IN THE UNITED STATES PATENT AND TRADEMARK OFFICE

In re Continuation Reissue Application)
of Serial No.: 08/341,585)
Inventor: Michel Gondouin) Group Art Unit
Serial No.: Unassigned) in Prior Application: 3625
Filed: September 4, 2001) Examiner in
For: DOWNHOLE EQUIPMENT, TOOLS) Prior Application: H. Dang
AND ASSEMBLY PROCEDURES)
FOR THE DRILLING, TIE-IN AND)
COMPLETION OF VERTICAL)
CASED OIL WELLS CONNECTED)
TO LINER-EQUIPPED MULTIPLE)
DRAINHOLES)

PRELIMINARY AMENDMENT

REQUEST FOR APPROVAL OF DRAWING CHANGES

FIG. 3

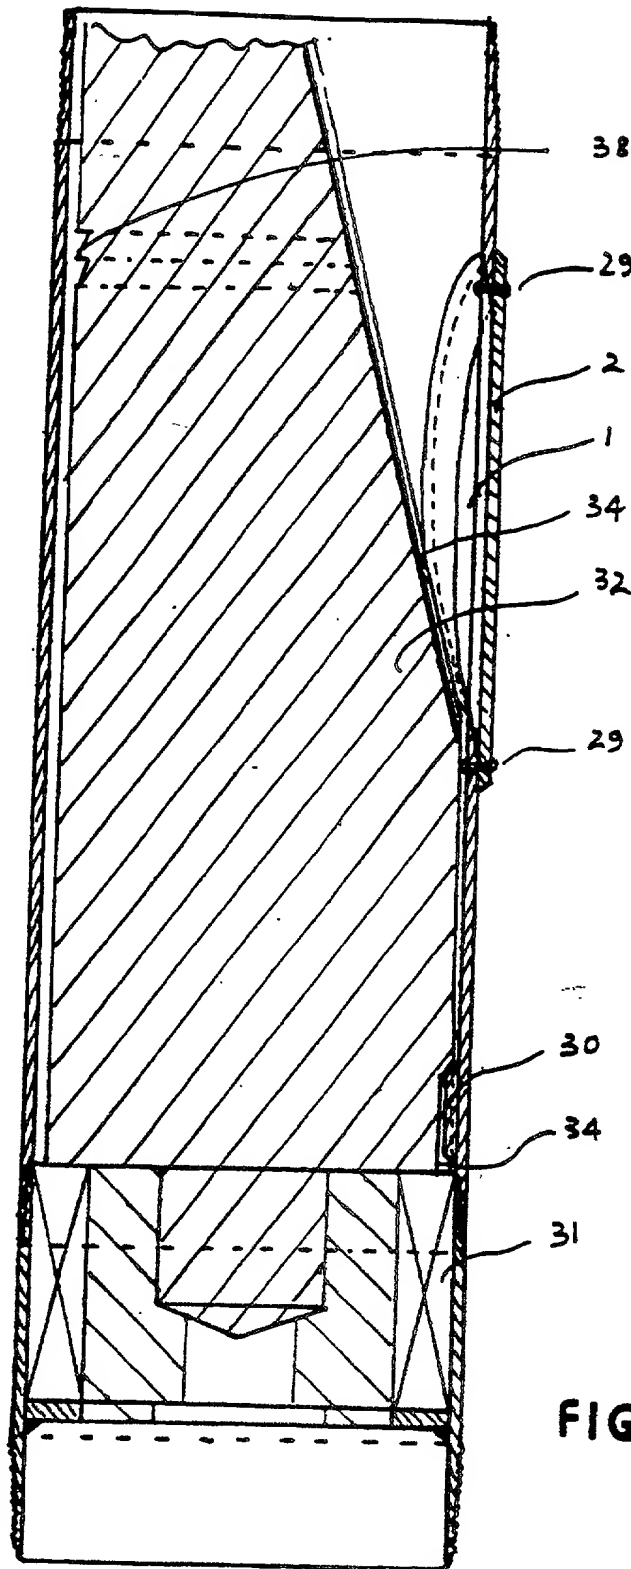
Pursuant to the condition of the Decision of this Office dated October 8, 1999, granting Applicant's Petition for the original filing date, please cancel Figs. 3 and 6 of the drawings from this application, as shown in Figs 3 and 6 in the attached Request for Approval of Drawing Changes in which the figures are enclosed within brackets (in red on the attached drawing) and identified as "CANCELED" (again in red). By these changes to Figs. 3 and 6, Application does not intend to cancel Figs. 3a, 3b, 3c, 6a, or 6b.

Applicant also requests that Figs. 3 and 6 be canceled in total according to reissue practice. As M.P.E.P. § 1413 requires, the original Figs. 3 and 6 are enclosed within brackets (in red on the attached drawings) and identified as "CANCELED" (again in red).

FIG.4

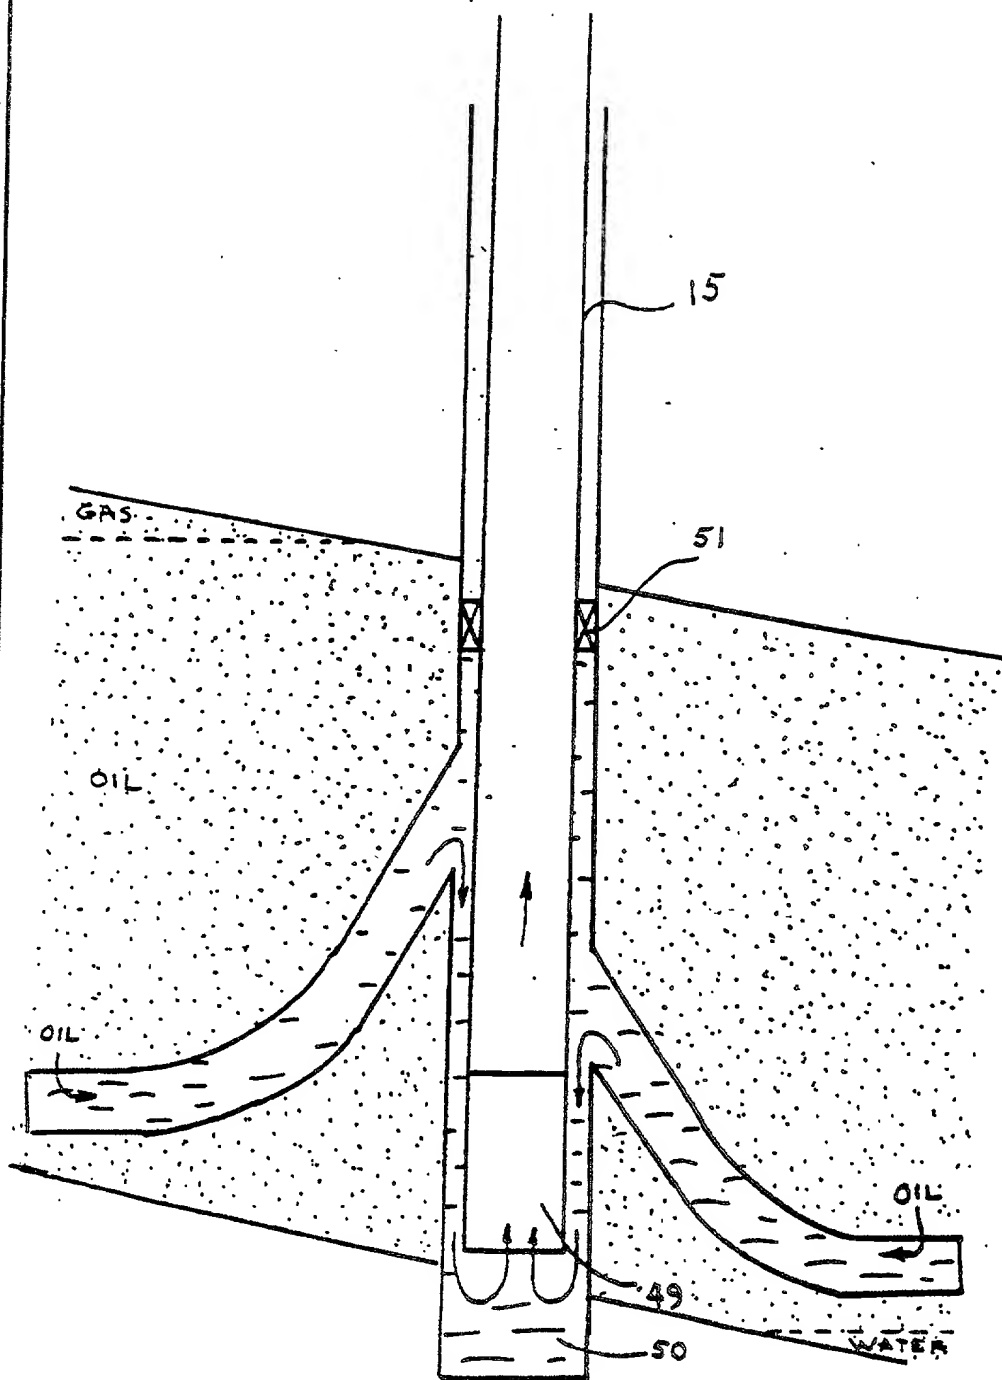
Also, please amend Figs. 4 and 10 as indicated in the attached Request for Approval of Drawing Changes.

With respect to claims 198-203, the Examiner expressed the view that there is no embodiment in the original disclosure which has all of the limitations of these claims. The Examiner asserted that embodiments shown in Figures 4 and 10 meet the limitation of "said pipe being maintained substantially within said housing during run in" but does not have a first window having a periphery and second bore extending from the first borehole coextensive with the first window.

New independent claims 8, 9, 11, and 13, define that the window of the housing is placed at a position where the second borehole is to be formed. As shown in Figures 4 and 10 and described in the specification, Applicant discloses a lateral seal and control system having a first borehole and a housing having a window aligned with a position where the second borehole is to be formed, as claimed in claims 8, 9, 11, and 13. *See e.g.*, 8:49-58; 9:13-16; 16: 11-23; 45-49. Applicant further discloses a production pipe having a flange dimensioned larger than the premachined window, wherein the pipe is maintained within the housing during run in and is movable from the run in position to a deployed position wherein the flange is mated against the periphery of said premachined window, as claimed in claims 8, 9, 11, and 13. *See, e.g.*, 8:54-67; 9:1-3; 8-16. In addition, Applicant discloses energizing the flange against the periphery of the window, as further claimed in claim 9. *See, e.g.* 8:57-60; 9:8-9. Applicant, therefore, respectfully submits that claims 8, 9, 11, and 13 are fully supported by the reissue application under 35 U.S.C. § 251.

Applicant is also presenting proposed amendments to Figs. 4 and 10. These proposed amendments were discussed during an interview with the Examiner in the parent application and were accepted by the Examiner in that case. Applicant is formally submitting the proposed drawing changes in the accompanying Request for Approval of Drawing Changes. These drawings are the same as the drawings considered and accepted by the Examiner in the parent application. Applicant submits that these proposed drawings fully comply with the Office's Rules and the MPEP.

Pursuant to 37 C.F.R. § 1.121, Applicant requests approval of the attached drawing changes. Applicant has submitted these changes by way of a new sheet of drawings with Figs. 4 and 10 identified as amended. 37 C.F.R. § 1.121(b)(3)(i). Moreover, these drawings constitute a sketch in permanent ink and the proposed changes are shown in red. 37 C.F.R. § 1.121(b)(3)(ii).
